ADDENDUM NO. 3

PROJECT:
Duluth City Hall Generator
Replacement
G&M Project No. 83295

DATE:
September 18, 2014

2 ENLARGED GENERATOR ROOM ELECTRICAL PLAN

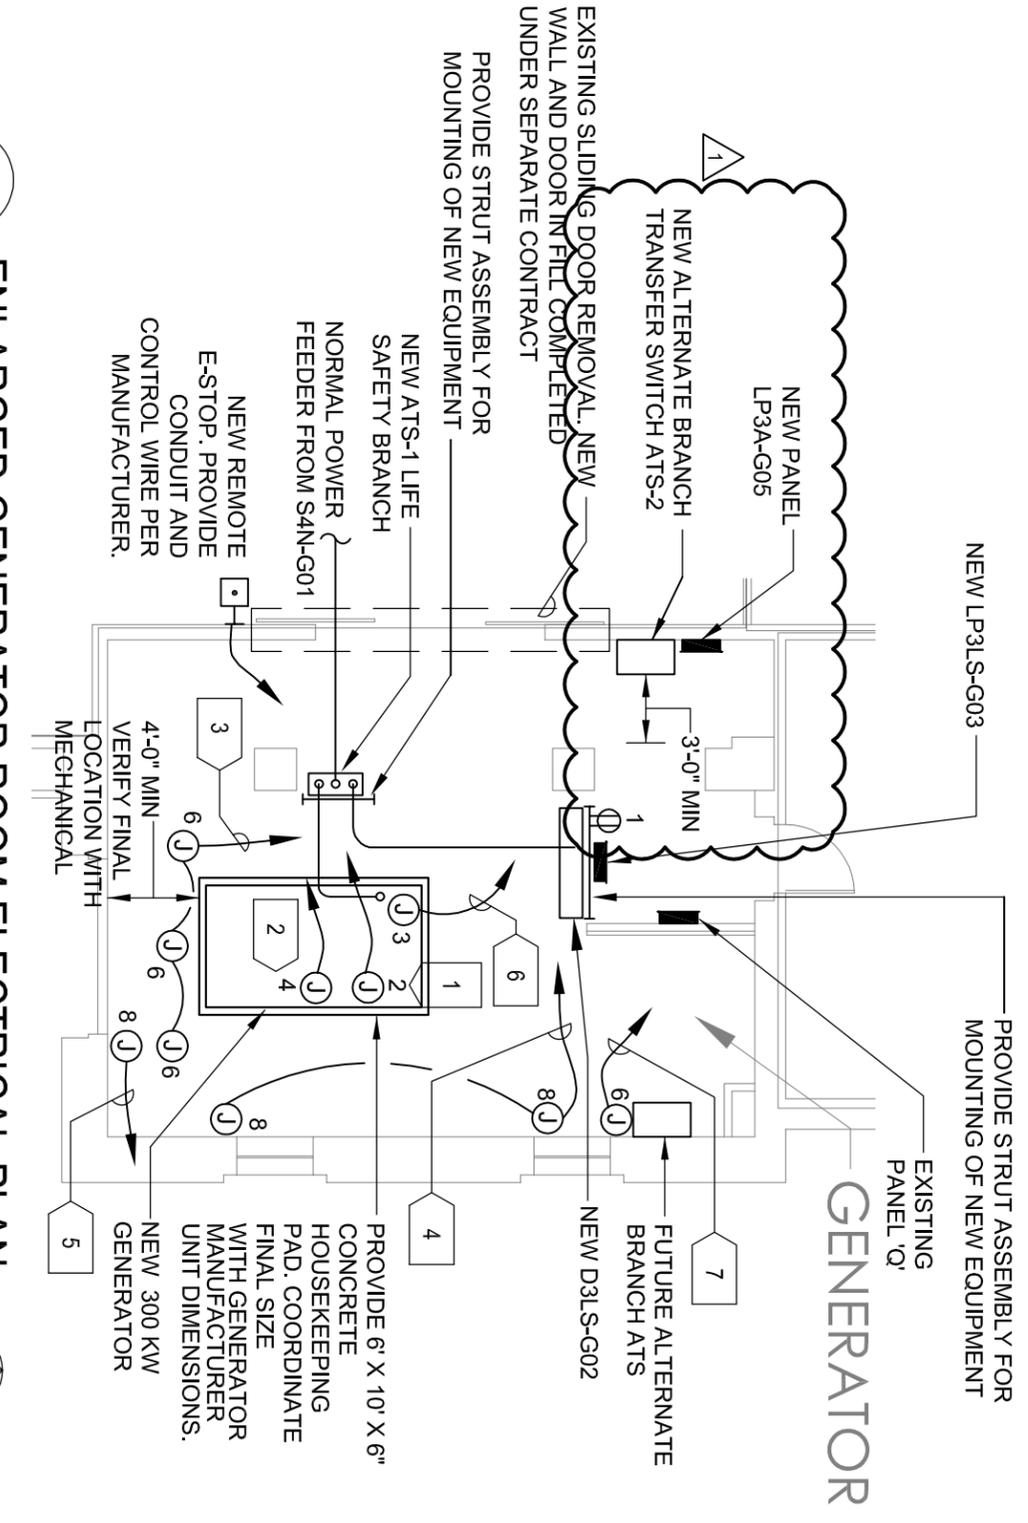
| 1. | E3.1 and E3.2 | Refer to attached for inclusion of ATS-2 and panelboard LP3A-G05 as add alternate. Include add alternate price on separate company letterhead and attach to bid form. |
